## Addendum

Project:	2024_004 Penhold Public Services Building	No. of Pages:	5
Addendum No:	03	Date Issued:	July 31, 2024

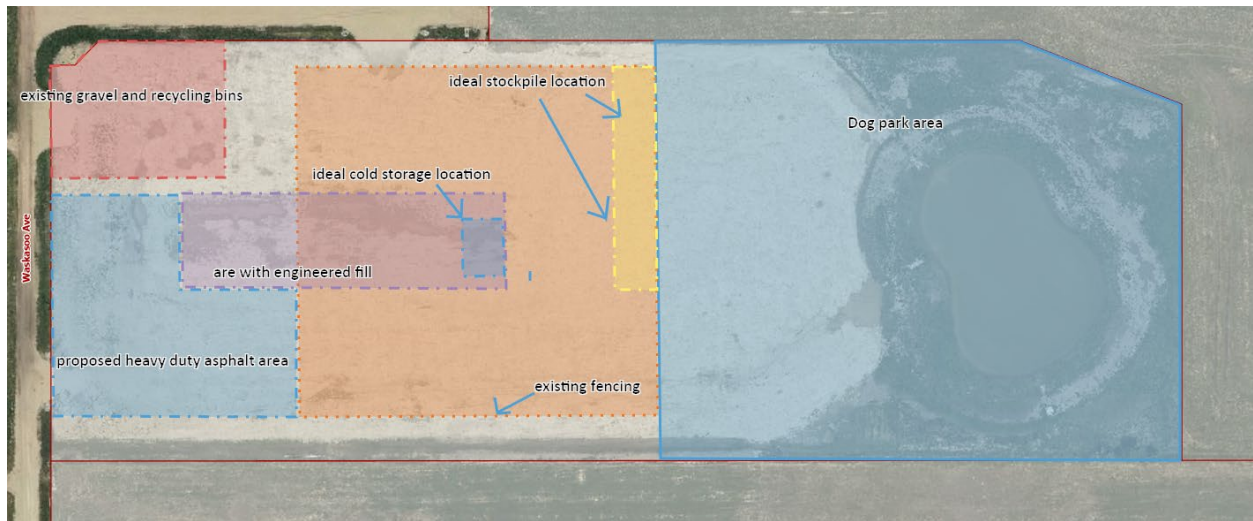
**1.1 Is the General Contractor allowed to develop the entire site, should the General contractor develop the entire site?**

Of the 20-acre parcel purchased by the owner, 8 acres has been developed into a storm retention pond and dog park, both of which are located on the flood fringe not suitable for construction of buildings. Referring to the map below will show the remaining 12-acre site that should be developed enough to function for the purposes of both departments.
